Certificate of Appropriateness Case Report

Filing Date: July 10, 2012
Case No.: **2012.0874A**
Project Address: **1470-1484 McAllister Street**
Landmark District: Alamo Square
Zoning: RM-1 (Residential, Mixed, Low-Density)
40-X Height and Bulk District
Block/Lot: 0776/035
Applicant: Tony Kim, Town Consulting
100 Clement Street, 3rd Floor
San Francisco, CA 94118
Staff Contact Shelley Caltagirone - (415) 558-6625
shelley.caltagirone@sfgov.org
Reviewed By Tim Frye – (415) 575-6822
tim.frye@sfgov.org

RE: Meeting Notes from Review and Comment at the
November 7, 2012 ARC/HPC Hearing for
1470-1484 McAllister Street

Re: Response to Review Comments at November 7th, 2012 ARC Hearing

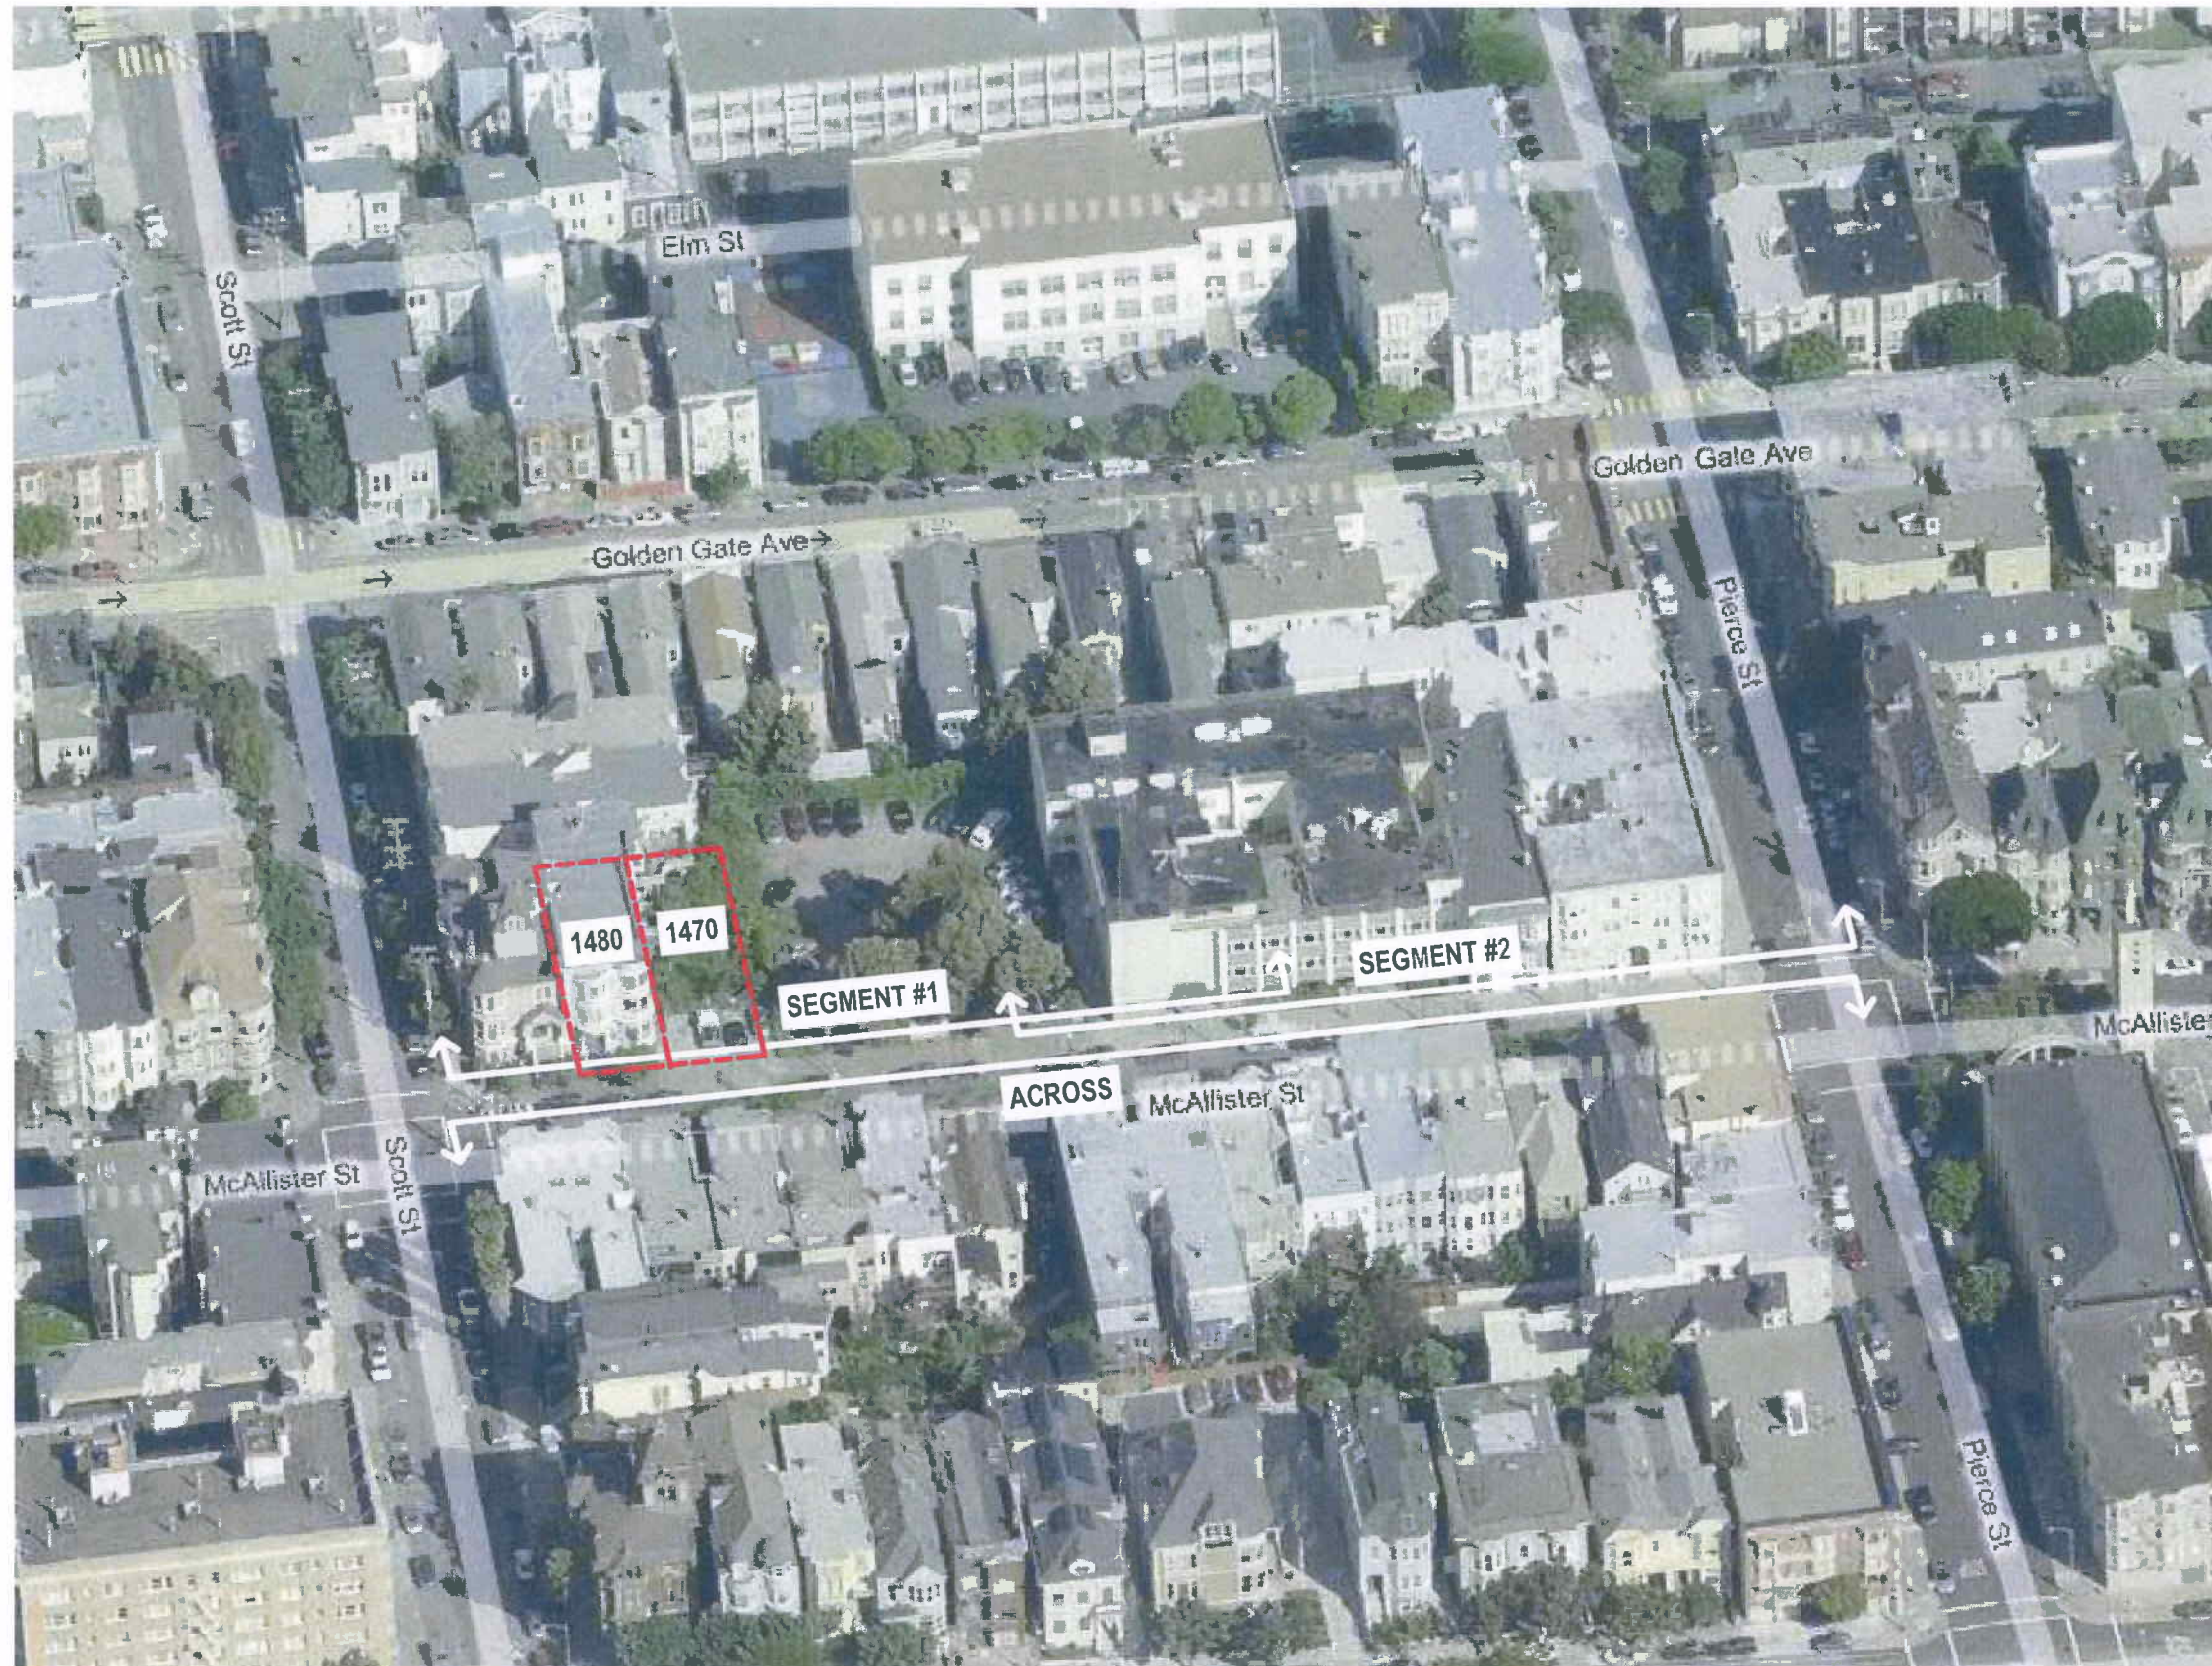
- c. **Canopy.** Commissioner Martinez commented that the canopy appears to be supporting the bay above but is not grounded itself. Commissioner Wolfram also noted that the height of the canopy does not relate to the height of the windows in the left bay and suggested that they be integrated in some manner. Commissioner Martinez

recommended adding vertical support to the canopy feature, particularly at the property line side.

c. Canopy:

The canopy is reduced and lowered to the same height as the left bay trims. Columns below provide more sound support for bay above.

PROPOSED FRONT ELEVATION

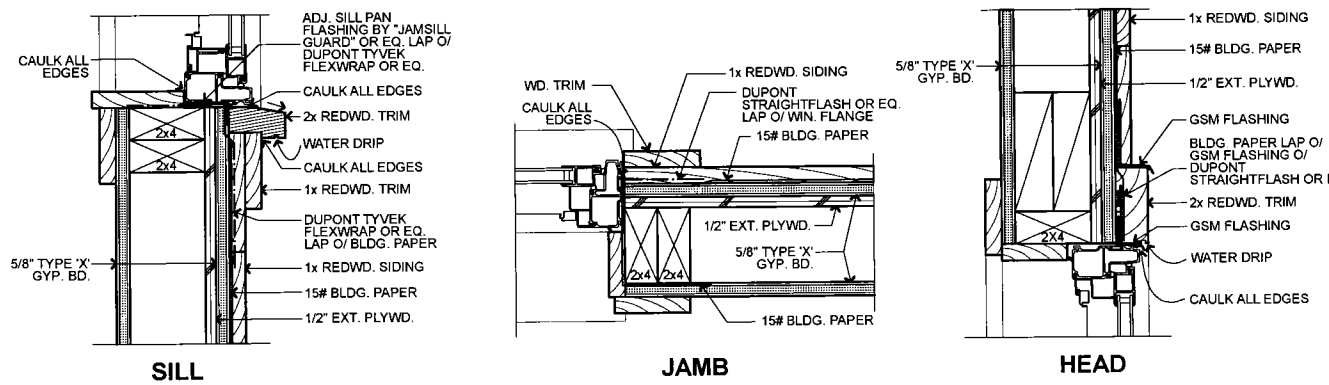
5. **Cornice treatment.** Commissioners Martinez and Wolfram agreed with the staff comment that the cornice design is bulky and bland. They suggested using multiple layers of trim to create a less abrupt joint between the cornice and the wall. Commissioner Martinez suggested that the stepping of the cornice could be more evenly spaced. He offered a sketch of this concept to the project team.

7. **Fenestration pattern.** Commissioners Martinez and Wolfram agreed that the overall fenestration pattern is appropriate; however, they felt that the façade is too solid in appearance and suggested several changes to window types and size to address this issue. Both Commissioners felt that the window sizes could be substantially increased. Commissioner Wolfram suggested that the upper story windows could be taller and Commissioner Martinez agreed. Both Commissioners recommended installing windows in the side walls of the projecting bays. Commissioner Martinez suggested allowing the windows to wrap the corners of the smaller bay above the entry without corner posts and Commissioner Wolfram agreed.

8. **Main entry.** Commissioners Martinez and Wolfram agreed that the main entry and the bay above should be better integrated. Commissioner Martinez commented that the entry appears unsupported and unordered.

9. **Ornamentation.** Commissioners Martinez and Wolfram both commented that the area between the upper windows and the cornice needs to be treated so that it does not appear to be blank. They suggested using multiple layers of horizontal trim to create a less abrupt joint between the cornice and the wall. Commissioner Martinez suggested using trim above and below the windows in the bay above the entry to relate to treatment in the other bay and better integrate these two features.

The cornice was modified to step up evenly per Commission Martinez's suggested sketch.

Bay windows have been increased on both bays in width and from 5'-6" height to 7'-0". Single hung windows have been replaced with casement ones. With the exception of the right bay fire-rated property line windows, all side windows now wrap around bay corners without corner posts.

The entry is now flanked by two columns, creating more integrated and solid support for the bay above as well as a more pronounced entrance characteristic of the neighboring building entries.

The trims above the windows have been simplified, with the top wrap-around wide band eliminated from the front façade. The bays now have a better transition to the cornice above.
